CALIFORNIA COASTAL COMMISSION

**RECORD PACKET COPY****W 4a****STAFF REPORT AND RECOMMENDATION****ON CONSISTENCY DETERMINATION**

Consistency Determination No. **CD-117-99**
Staff: JRR-SF
File Date: 12/16/1999
45th Day: 01/30/2000
60th Day Extended to: 04/25/2000
Commission Meeting: 04/12/2000

DEVELOPMENT**DESCRIPTION:**Lower Mission Creek flood-control improvements
(Exhibit 2-9)**EXECUTIVE SUMMARY**

VEGETATED SIDE SLOPE AND VERTICAL WALL SECTION VIEW

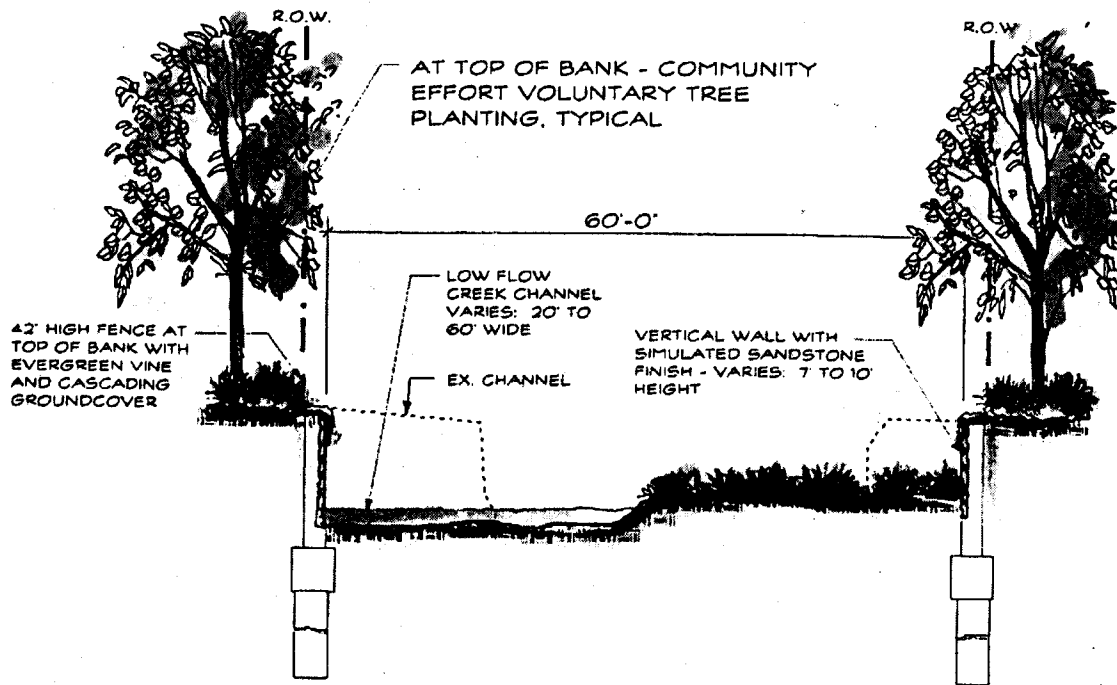
6. **Visual Resources.** The Corps should revise its consistency determination to analyze a smaller-scale version of the proposed project that may increase the amount of vegetated side slopes, and thus reduce the visual impact from the project. Additionally, the Corps' consistency determination should include a detailed description of the project's aesthetic design features.

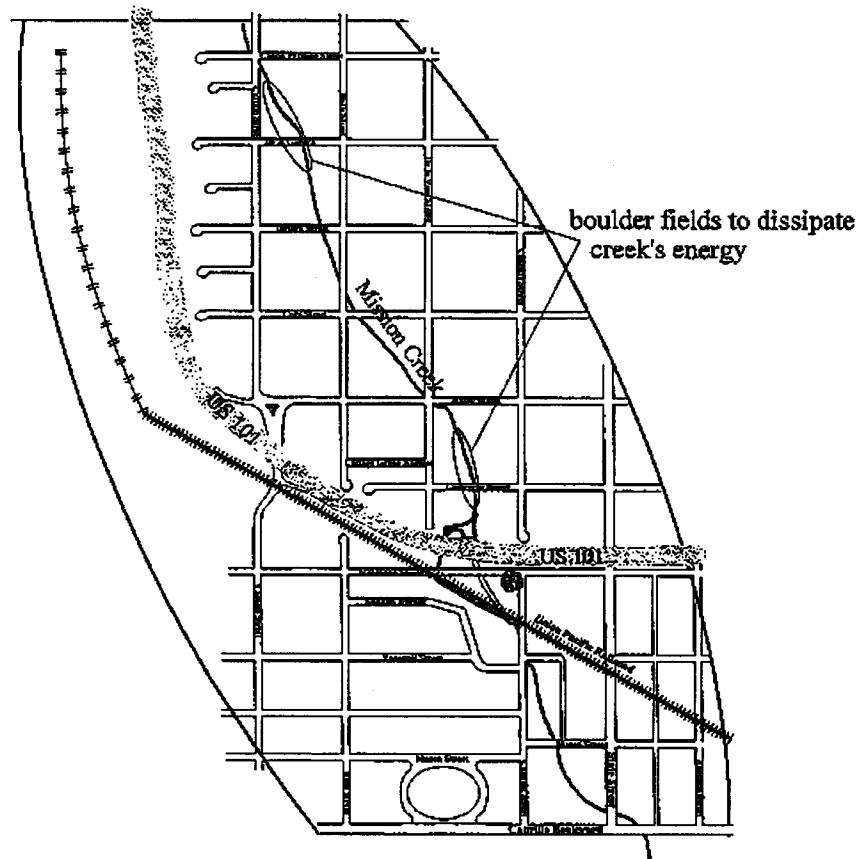
The Commission is concerned that the proposed mitigation is not adequate to address project impacts. As described above, the proposed project will significantly change the nature of the stream and estuary. These changes include potential increases in water temperature, sedimentation, and pollution. In addition, the annual maintenance activities will result in regular disturbances to this sensitive habitat. Finally, the removal of aquatic vegetation and bank vegetation within the estuary will result in a reduction in the input of nutrients into the stream and estuary. The Commission believes that these changes will significantly reduce the value of Mission Creek for both the tidewater goby and the steelhead trout. This conclusion is supported by the Corps' own analysis, which shows that the habitat value of the aquatic area will be significantly reduced.

Since the aquatic habitat supports threatened species, the Commission believes that the mitigation proposed by the Corps should focus on this resource. However, the Corps' mitigation focuses on improving bank habitat and avoiding construction impacts. Although the Commission recognizes that the Corps proposes some aquatic habitat enhancements, these benefits are inadequate to address long-term habitat impacts to the aquatic resources. The aquatic benefits include placement of boulders within the two small sections of the stream corridor as energy dissipaters, removal of existing cement from the streambed, and widening of the estuary. The proposed boulder fields will increase stream habitat

by adding riffles and pools to the stream. Additionally, the Corps will allow some aquatic vegetation to exist within the boulder field. However, the benefits of these improvements are limited to two small portions of the creek (as shown in the map below) and will not significantly add to the habitat value of the stream.

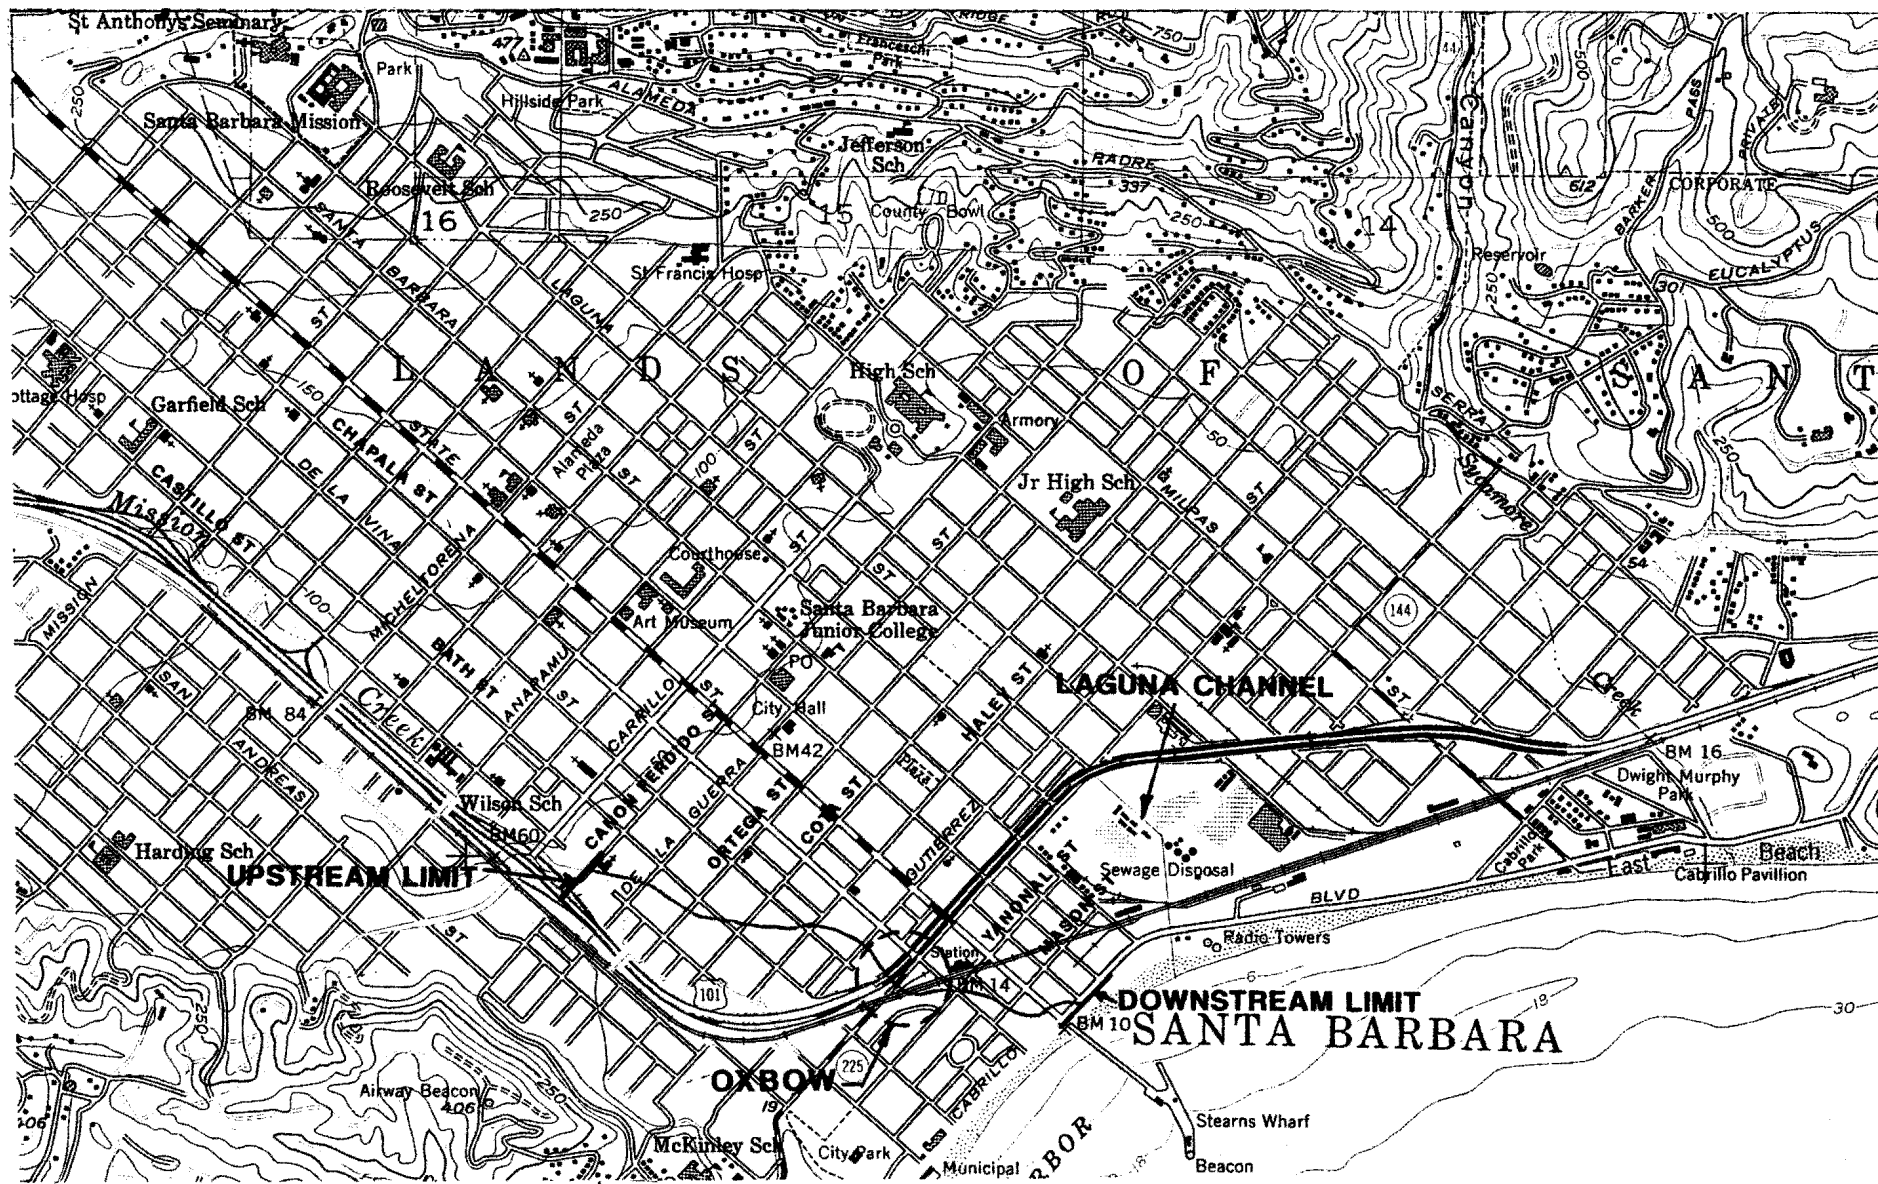
As stated above, most of the Creek within the coastal zone would be developed with vertical walls and would not appear as a natural stream. Although the area is already developed with some man made structures, it still has some natural appearance. The proposed project would change that appearance to a channelized hardened stream.

The Commission has two concerns with respect to the Corps' analysis of visual impacts. First, as described in the Habitat Section above, it is not clear that the construction of vertical walls is necessary. Until the Corps provides additional information that justifies the need for the walls, the Commission considers the use of vegetated slopes to be a less visually damaging alternative. If the Corps can demonstrate that the vertical walls are necessary, the second concern of the Commission is that aesthetic design improvements proposed by the Corps are not described in detail and the Commission cannot determine if the improvements would sufficiently mitigate for visual impacts. Without this

information, the Commission cannot determine if the project is consistent with the visual policies of the Coastal Act. Therefore, the Commission finds that the consistency determination for the proposed project does not provide enough information to determine if the project is consistent with the view protection policies of the Coastal Act.
